RE: Application Number PL2025207  
Highway 50 and 291  
Lee's Summit, MO

The following is provided as the formal sign code modification request on the behalf of East Village Investors, LLC for the East Village preliminary development plan application number PL2025207. As you are aware, Section 13.210 of the City of Lee's Summit sign code permits one free standing sign per lot. In summary, the sign code requires the following:

RE: East Village  
Application Number PL2025207  
Highway 50 and 291  
Lee's Summit, MO

**RE: Modification Request for Lee's Summit Costco Preliminary Development Plan Narrative Preliminary Development Plan (PDP) in the EnVision LS Area Overlay District.**

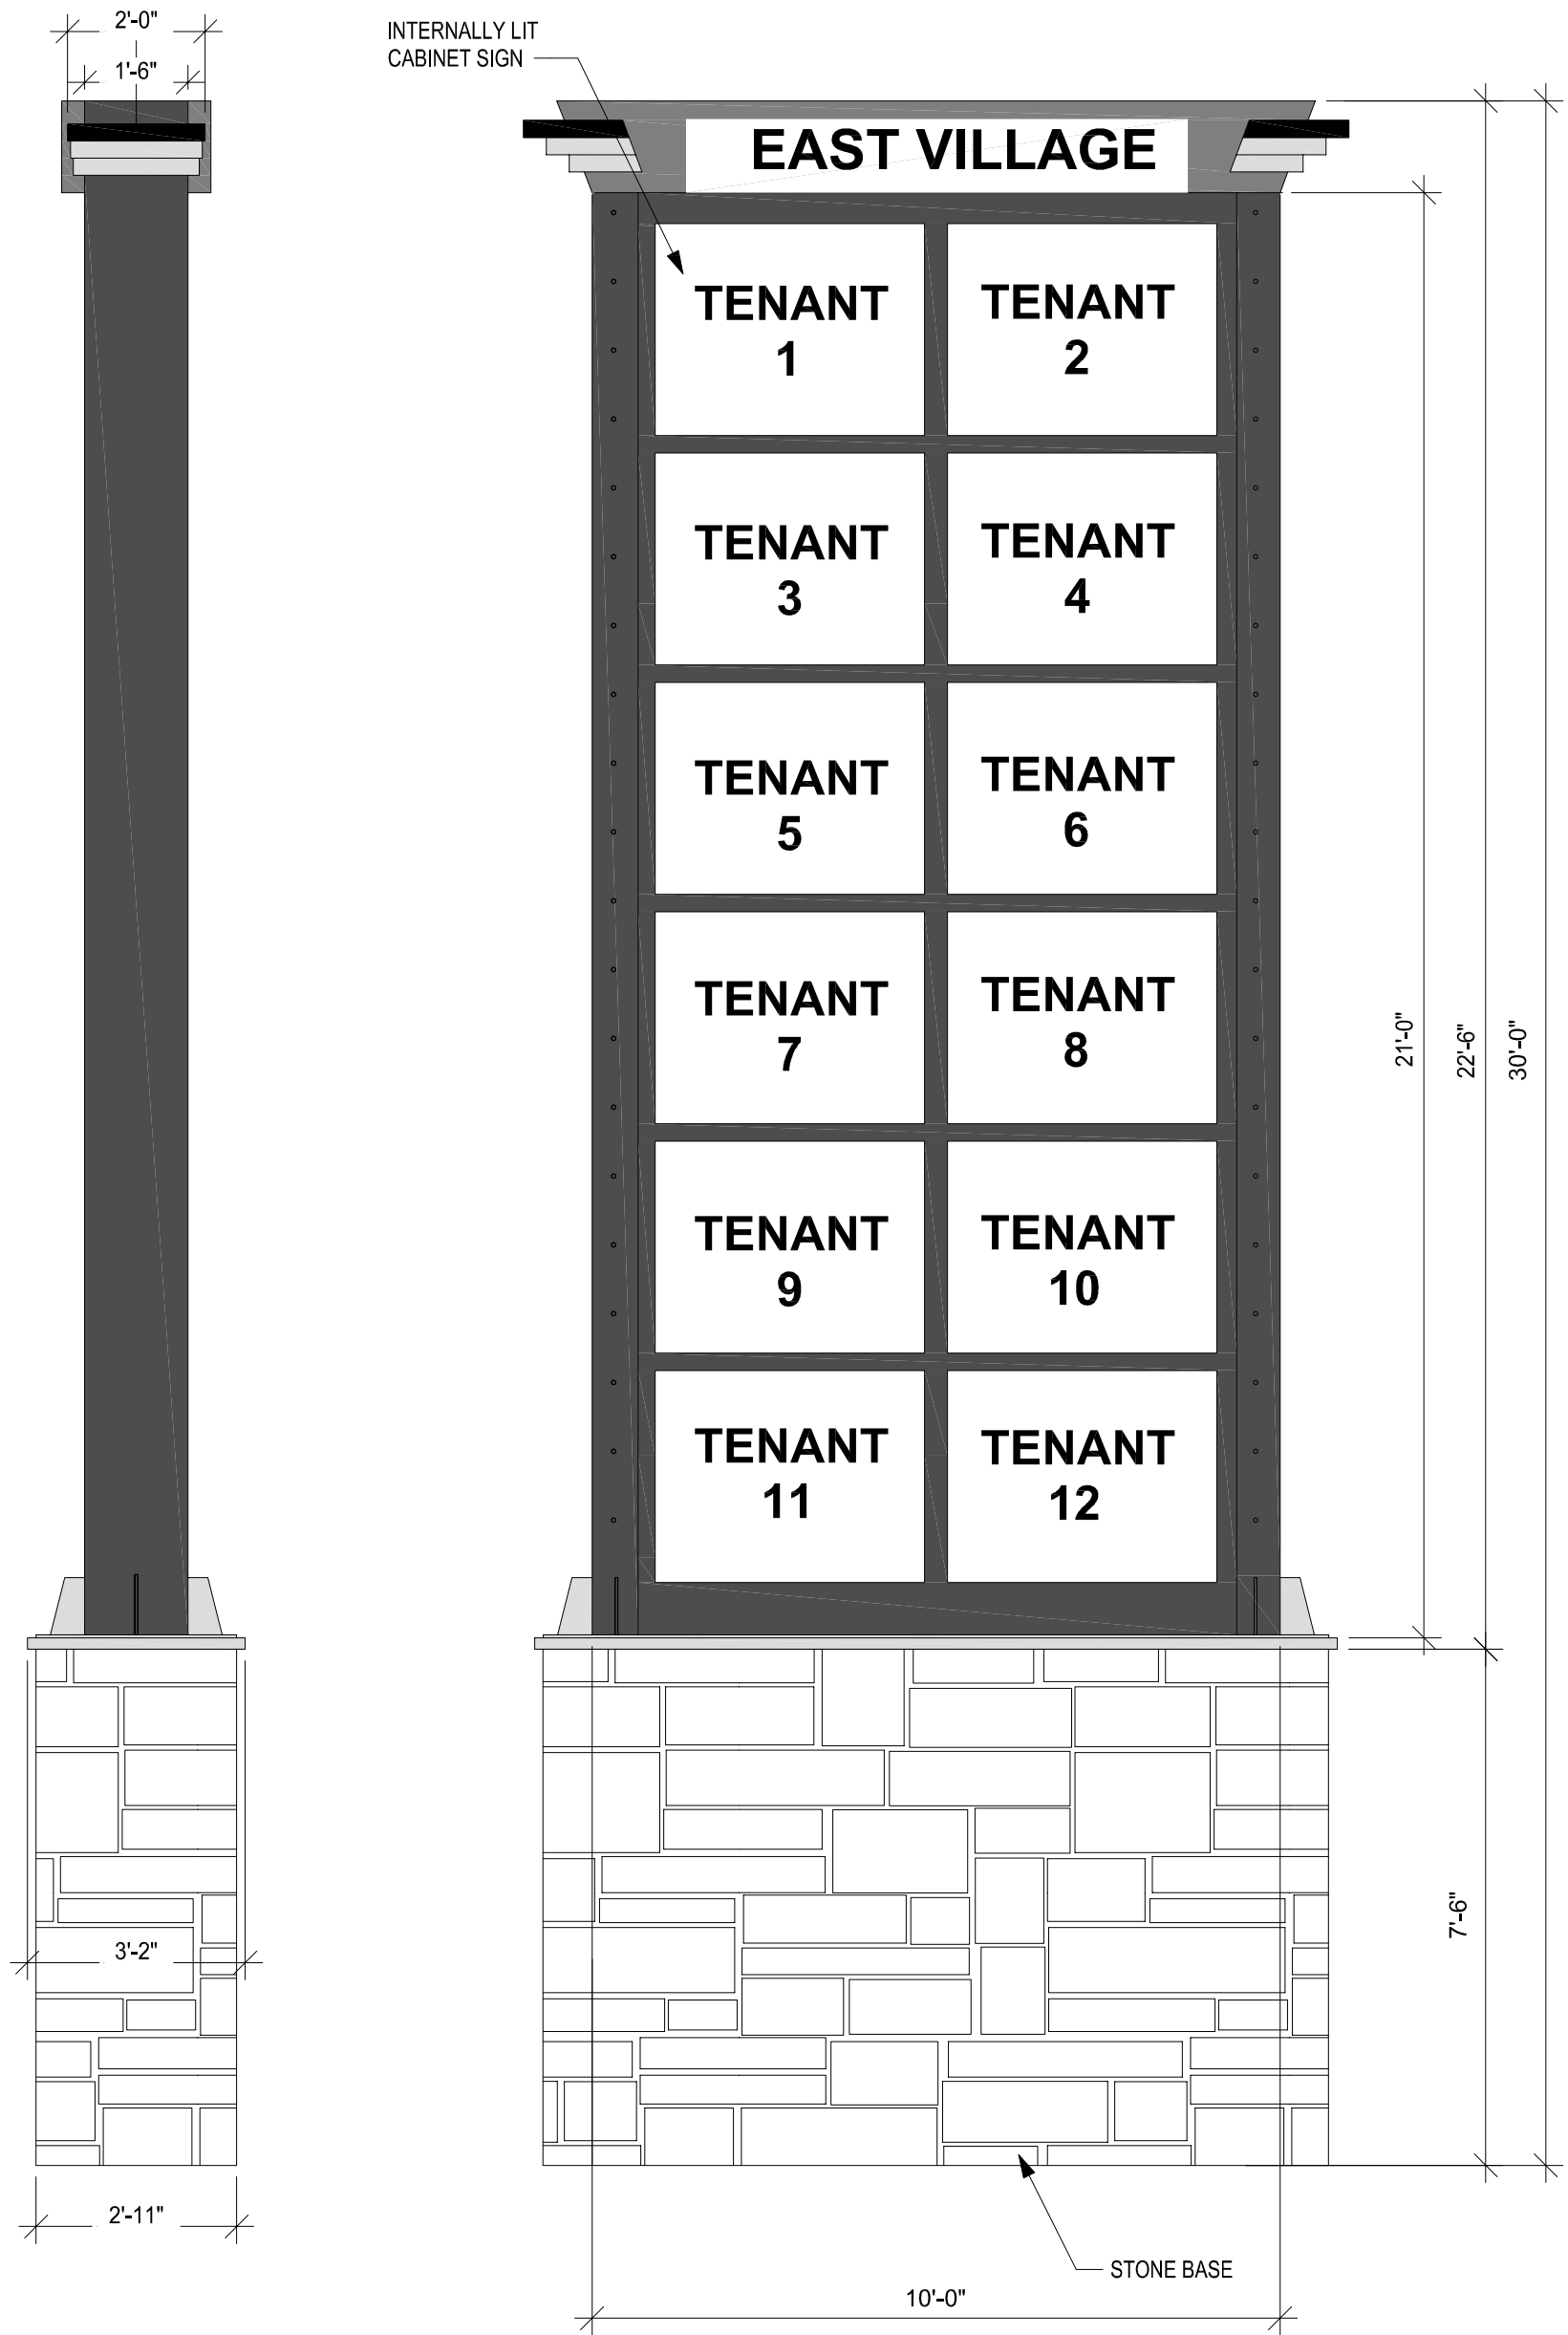
- Roof-mounted mechanical equipment: The ordinance states that roof-mounted mechanical equipment shall be screened by a parapet wall of equal height to the equipment. We are providing parapet walls to screen the roof-top equipment, but they are not the same height as the equipment. However, the parapet walls effectively screen the equipment from view, as intended by the ordinance. See included sight line study.
